Loose Exhaust Manifold Mounting Screws—75/90/115 FourStroke (2.1L) and 65/80 Outboard Jet FourStroke (2.1L)

Please contact your Mercury Outboard dealer and mention Outboard Service Bulletin 2014-11 to schedule an appointment to have this repair performed. Your dealer will be able to determine how long this repair will take.

57459

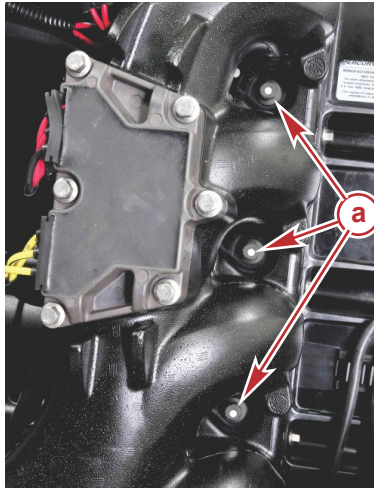
All outboards that have had the center three exhaust manifold screws torqued will be identified in the following two ways:

- A blue dot sticker applied to the serial number mat on the engine shipping carton.

- A white paint mark applied to the center three exhaust manifold screws.

- a - White paint mark
- b - Blue dot sticker
